T-mobile Usa, Inc.

Subject: Requesting Class II permissive change for FCC ID : **2ASXC-TMO-NBT-01**

The purpose of this letter is to request a Class II Permissive change for FCC ID: **2ASXC-TMO-NBT-01**

Add a Metal Sheet for Button

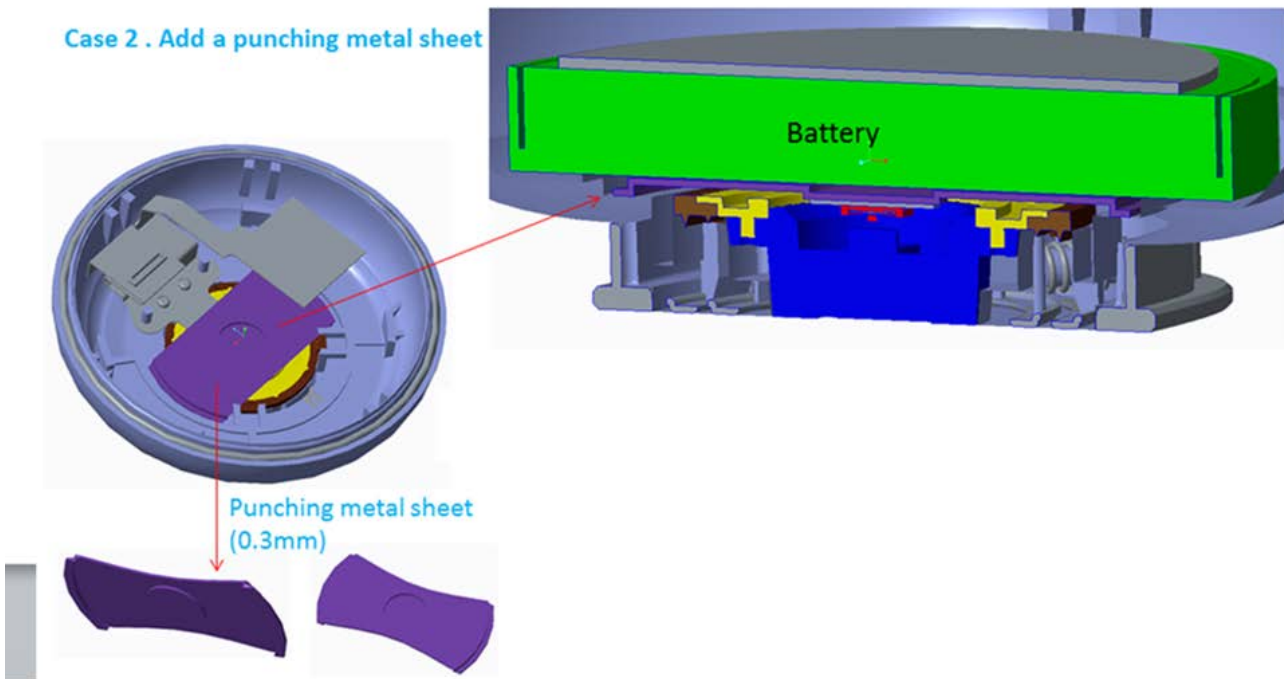
add a metal sheet for button as below shows :

Case 2 . Add a punching metal sheet

The proposed change does not affect the conducted output power or antenna gain therefore testing was limited to just radiated spurious emissions. RF exposure was not reassessed because output power remains unchanged
